Information Only Service Note

N5171B X-Series EXG Analog Signal Generator

The Problem – Installing a new A5 CPU Assembly during a repair requires firmware version B.01.75 or newer, and different thermal pad placement.

Figure 1 – NEW A5 CPU Thermal Pad Placement

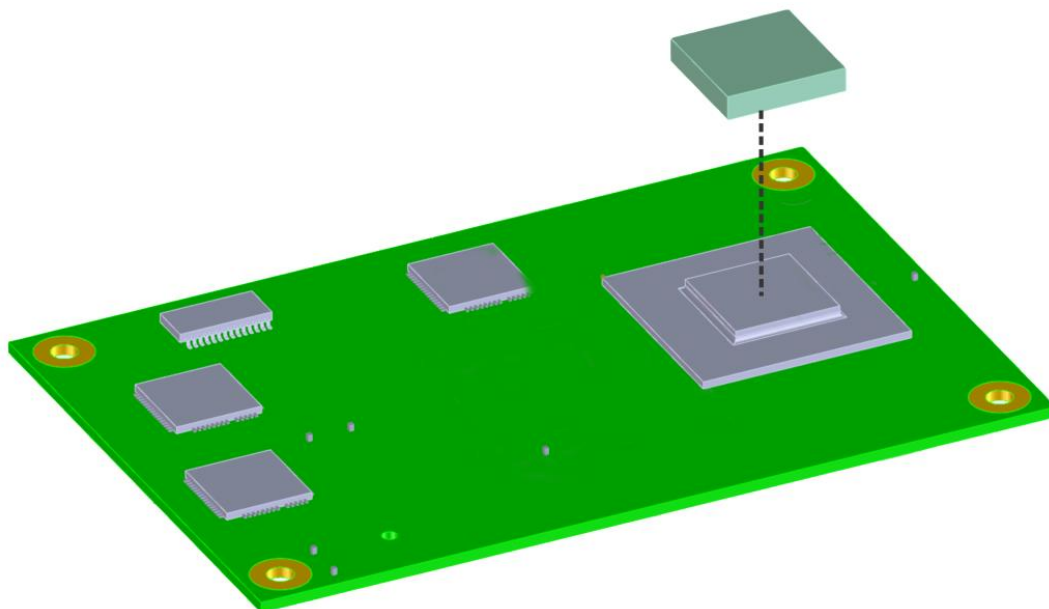
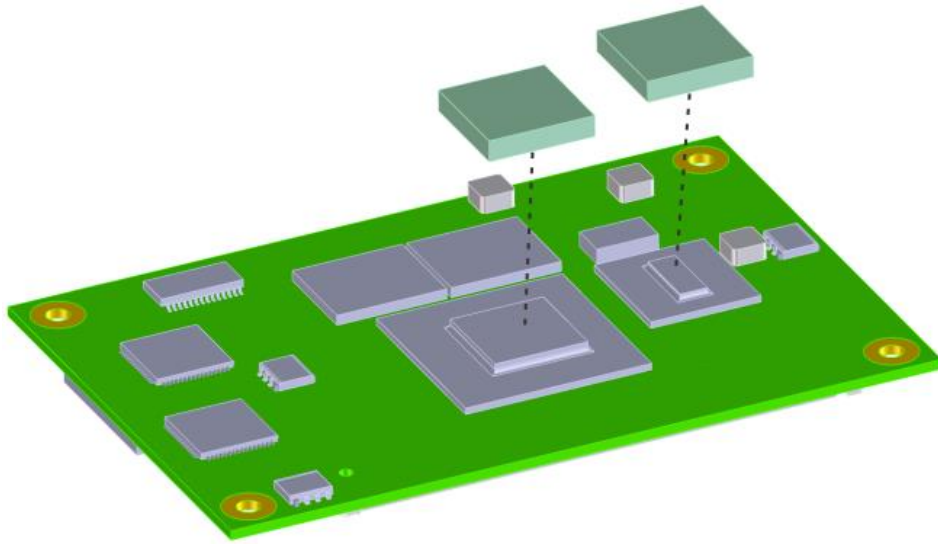
Thermal Pad
The new A5 CPU assembly requires only one thermal pad, while the old version required two. The placement of the single thermal pad for the new A5 CPU is as shown in Figure 1, and the placement of the two thermal pads for the old A5 CPU is as shown in Figure 2.

Replacement kits that contains the new A5 CPU assembly come with only one thermal pad.

Before installing a replacement A5 CPU assembly make sure that there are no old thermal pads stuck to the bottom of the A5MP1 CPU Heatsink from the previously installed A5 CPU assembly.
